September 2, 2026

John Wiesemann, Code Enforcement Officer
Town of Casco
635 Meadow Road
Casco, Maine 04015

**Re: Response to Review Comments
 Country Village Assisted Living Expansion
 960 Meadow Road
 960 Meadow Road Holdings, LLC - Applicant**

FOR RECORD OWNER:
960 MEADOW ROAD HOLDINGS, LLC
960 MEADOW ROAD
CASCO, MAINE 04015

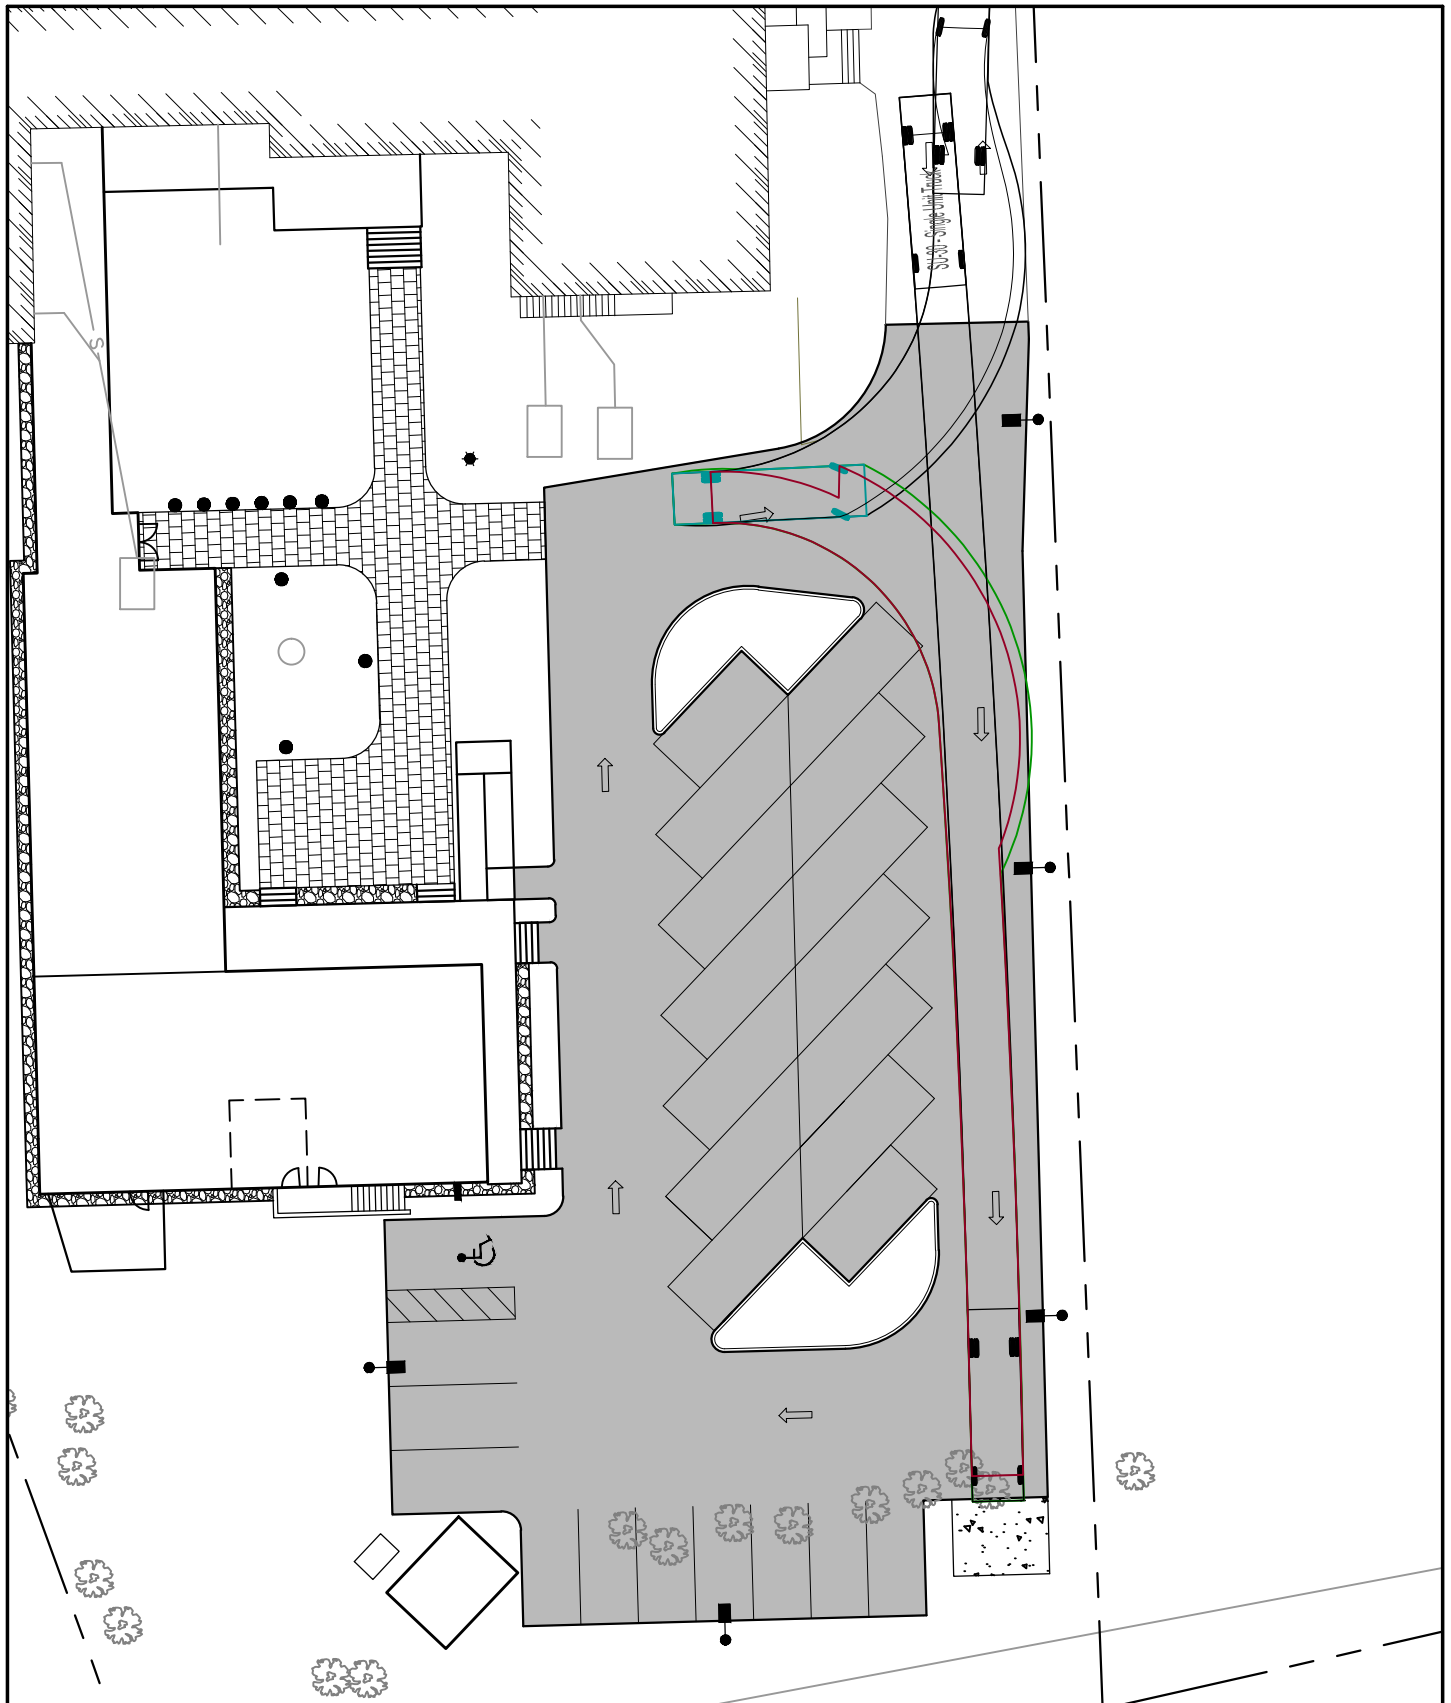
Comment 7 - *The turning radius for vehicles around the rear island is tight and the lane narrows to 16 feet due to the angular parking. A turning template should be shown to see what the largest vehicle is that can manipulate the turn. Teh concern is larger trucks might not be able to maneuver if cars are parked there.*

Response 7 – Included in this submission are turning movement exhibits for the different vehicles that would typically be onsite.

1 NEW ADDITION BASEMENT AND FOUNDATION
1/4" = 1'-0"

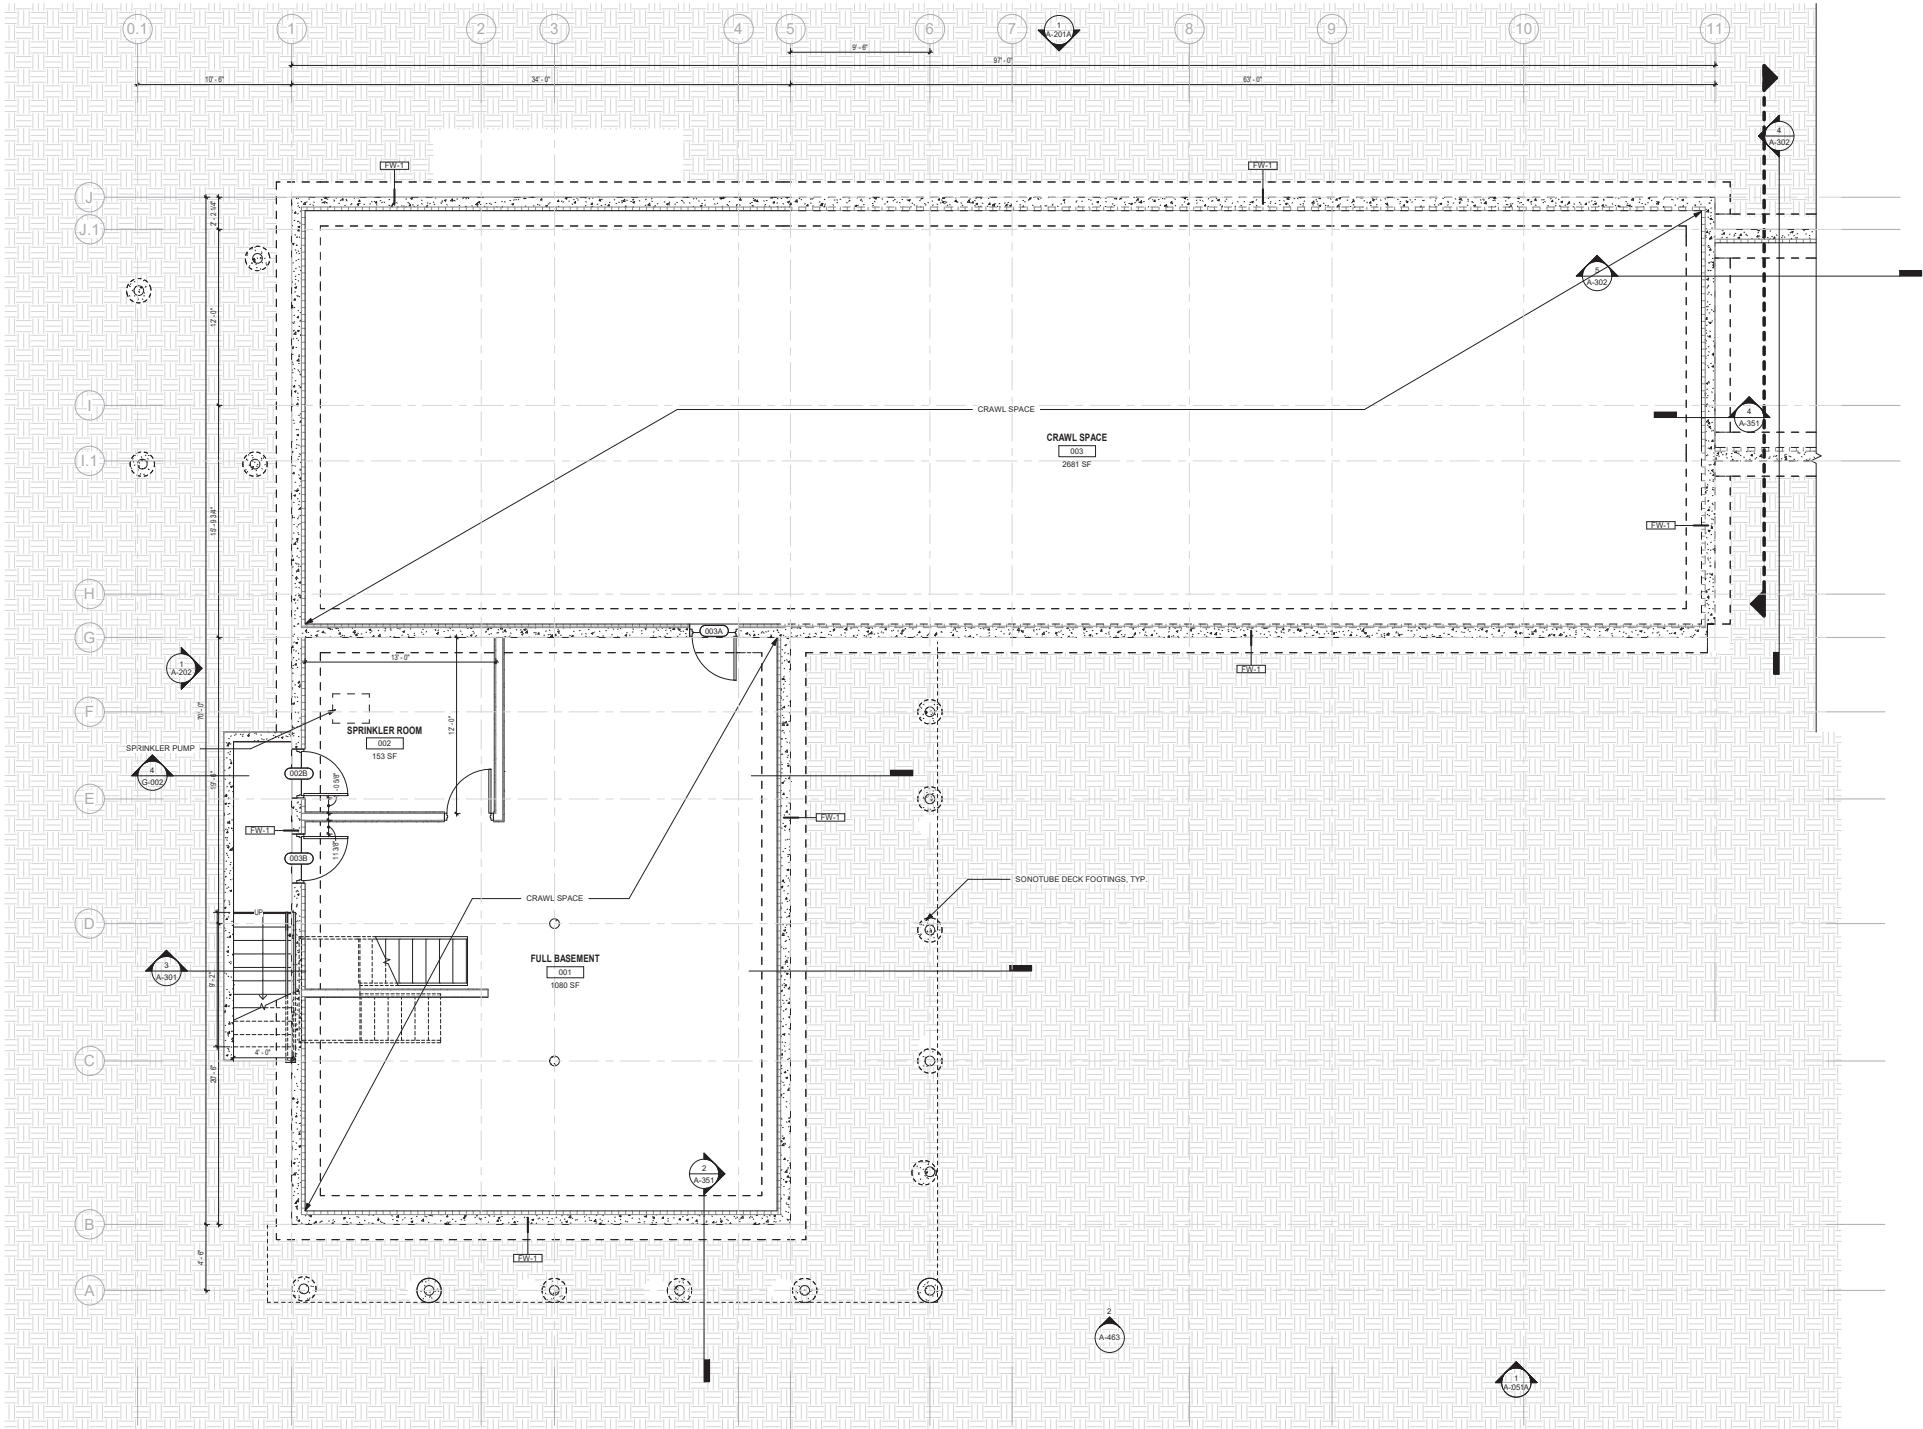
- **Building Foundation Revisions**
 - SW Cole was contracted with to provide geotechnical engineering services for the new building expansion. As part of the investigation, SW Cole performed test borings in the location of the proposed expansion. The results indicate there is relatively shallow bedrock in the majority of the footprint, especially where the original full basement section of the building was designed. To reduce rock excavation, the full basement area was moved from the northern side of the building to the southwestern corner, where the bedrock abruptly drops.

As a result, the exterior stairs to the basement were relocated to the western side of the building. To provide the space for the new staircase, the parking lot pavement had to shift to the west approximately 2 feet.

Adjustments to the utilities were also revised to enter the building at the full basement including the water lateral serving the new expansion’s domestic and sprinkler system and sewer service lateral leaving the building into a new septic tank.
